**Addendum No. 001**

**Subject: 2020 Classroom Modernizations**  
**SDP Contract Numbers: B-028 C of 19/20 & B-030 C of 19/20**

**Location: Overbrook Educational Center**  
**6722 Lansdowne Ave, Philadelphia PA 19151**

**This Addendum, dated March 6, 2020, shall modify and become part of the Contract Documents for the work of this project. Any items not mentioned herein, or affected by, shall be performed strictly in accordance with the original documents.**

1 ELECTRICAL THIRD FLOOR LIGHTING PLAN  
1/8" = 1'-0"

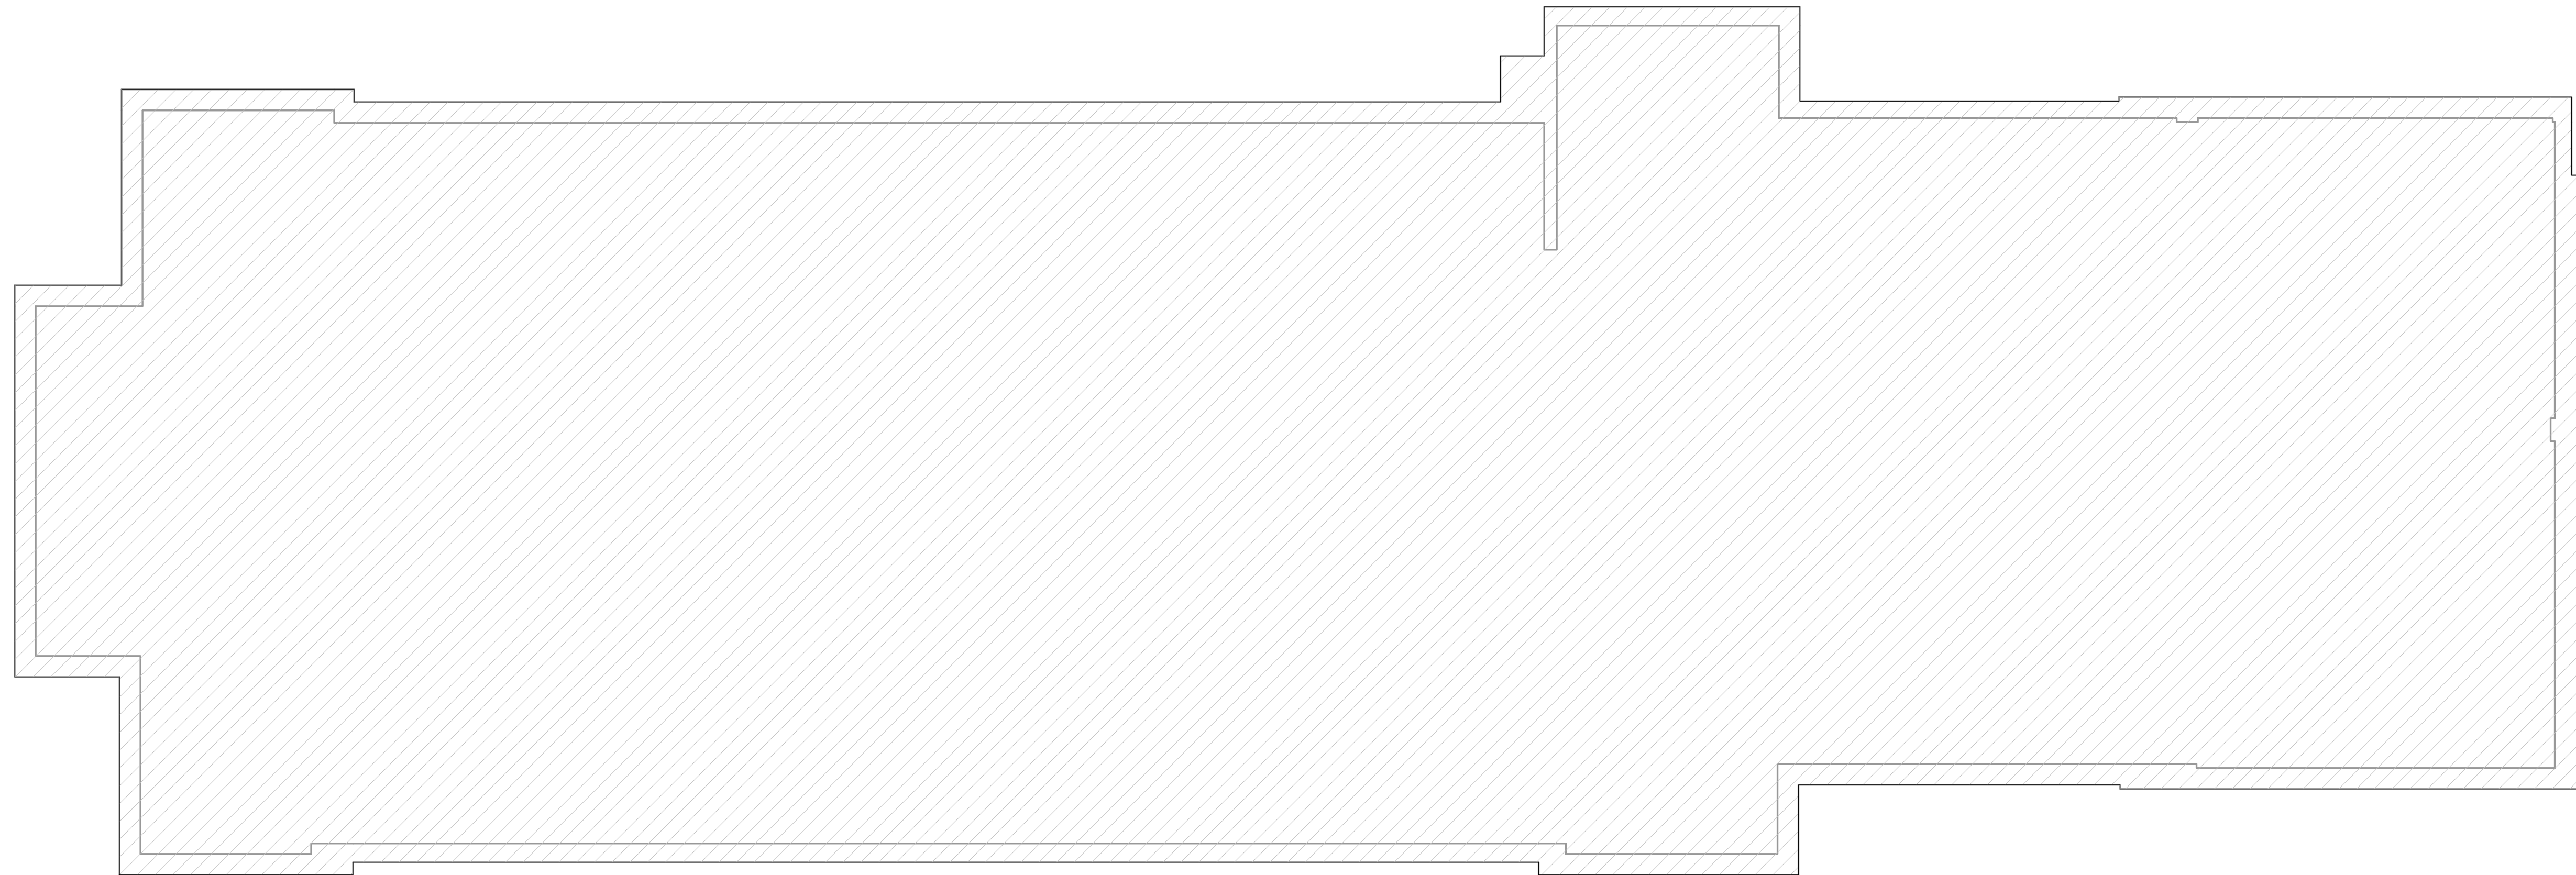
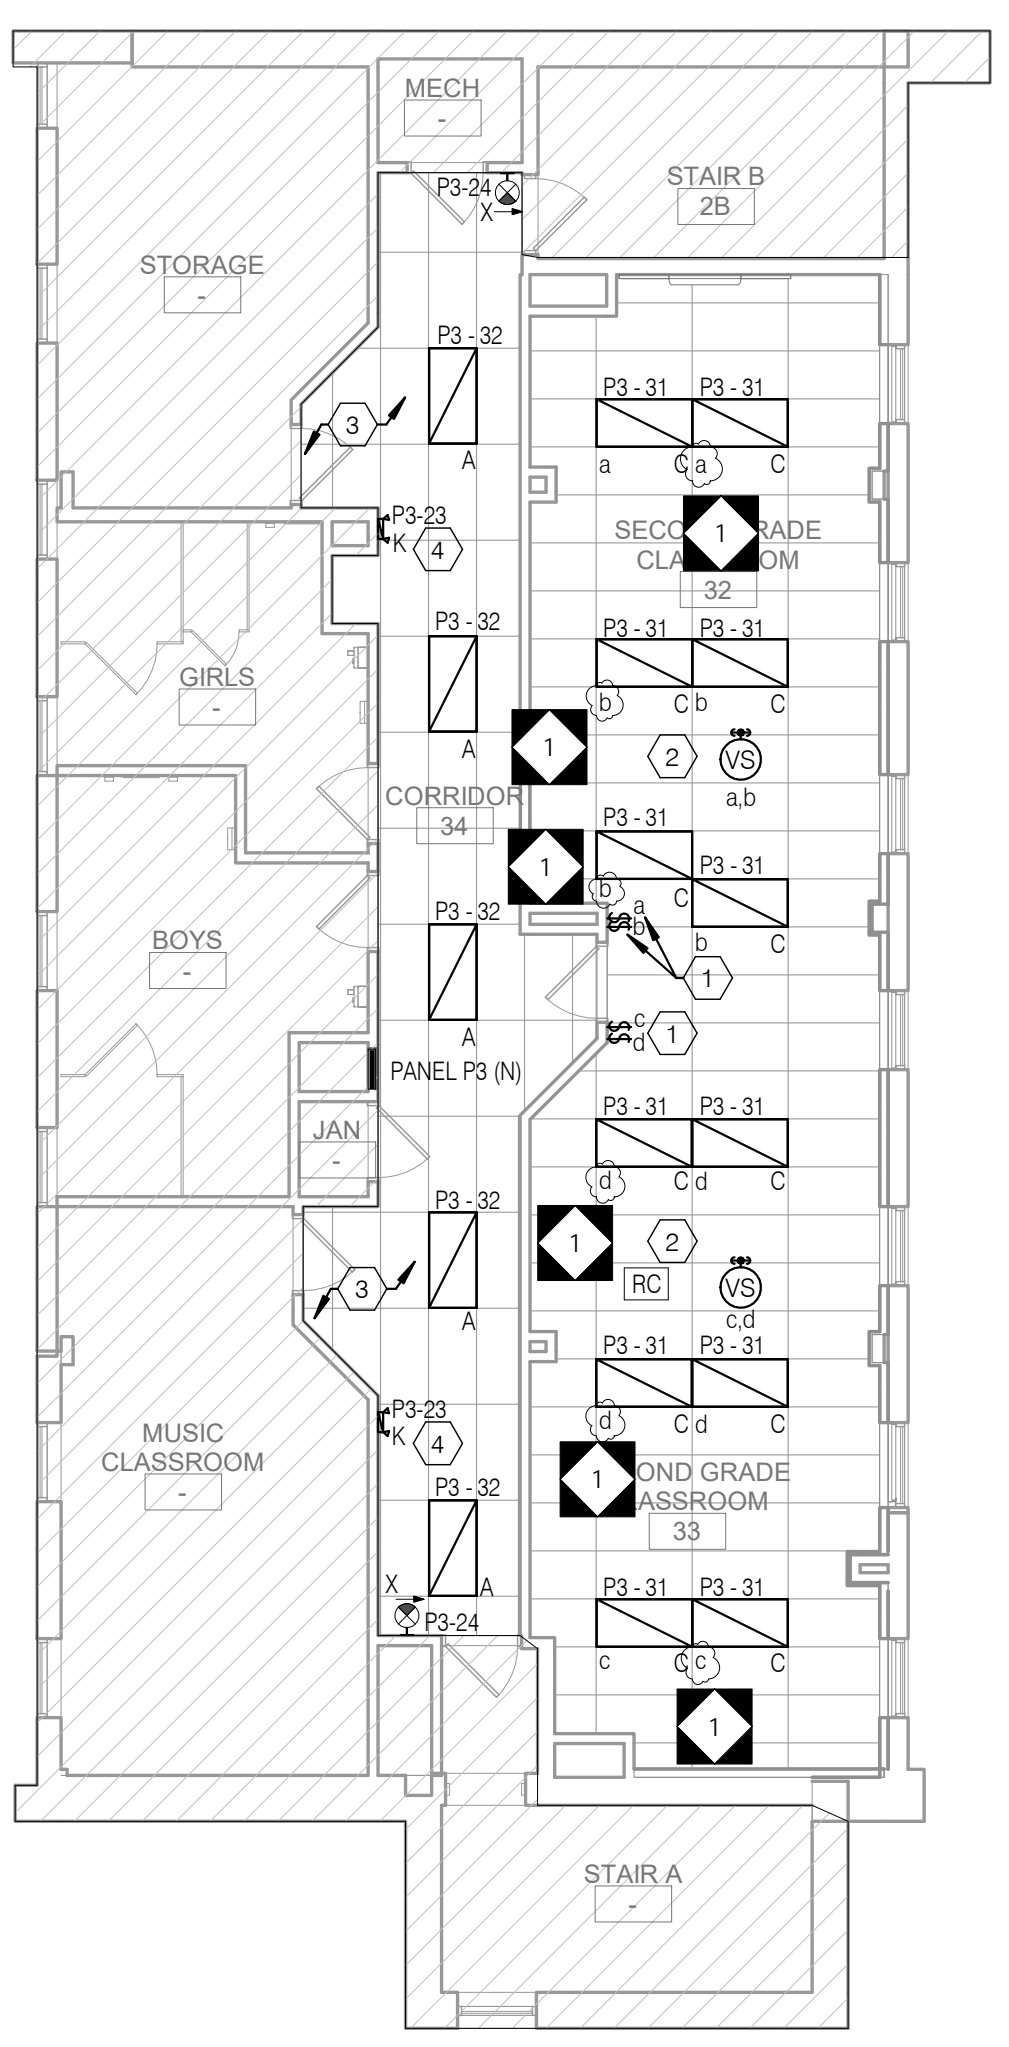
1. REVISE lighting zones as indicated on the drawings.

**1** ELECTRICAL FIRST FLOOR POWER PLAN  
E2.1 1/8" = 1'-0"

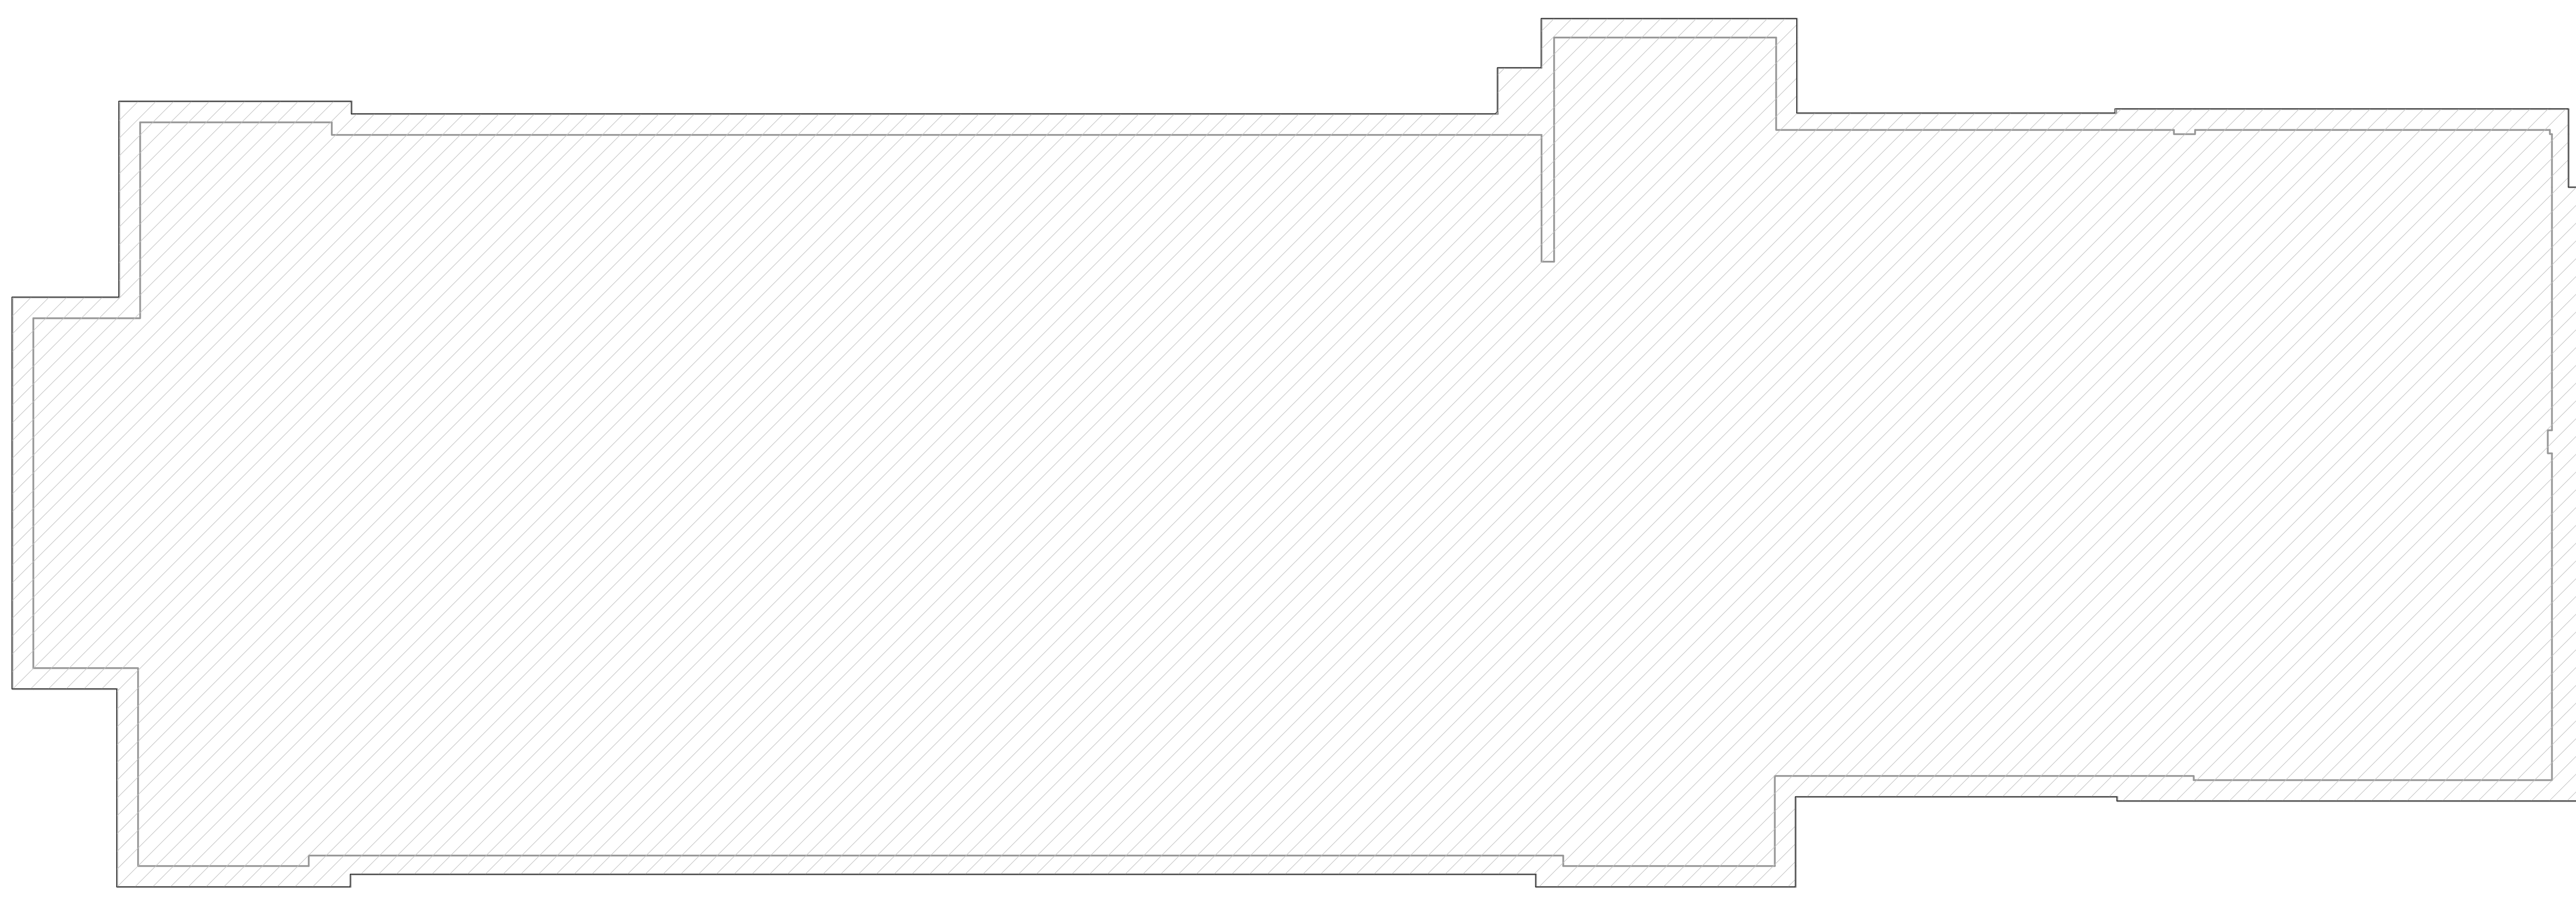
1. ADD general sheet note #6 to read "ELECTRICAL CONTRACTOR TO RUN ALL NEW SURFACE MOUNTED CONDUITS AND RACEWAYS IN CORNERS OFF EACH CLASSROOM TO AVOID CONFLICT WITH DISPLAY BOARDS AND OTHER CLASSROOM FURNISHINGS."

2. REVISE power layout in Kindergarten Classroom 1 per new room layout.
3. DELETE new data outlet from beside laptop charging receptacle.
4. REVISE location of Panel P1 per new wall configuration.

5. ADD relocated wall mounted speaker in Small Group Instruction 7.
6. DELETE GFI receptacle for water cooler.
7. ADD receptacle for laptop charging in Small Group Instruction 7.

8. REVISE receptacle locations per new smart board layout in Small Group Instruction 7.
9. ADD existing to remain receptacles in Staff Break 5.
10. ADD new data outlet in Staff Break 5 for relocated copier.

11. ADD junction box for connection to relocated hydration station.
12. ADD keyed sheet note 13 to specify scope of work for electrical connection to hydration station.
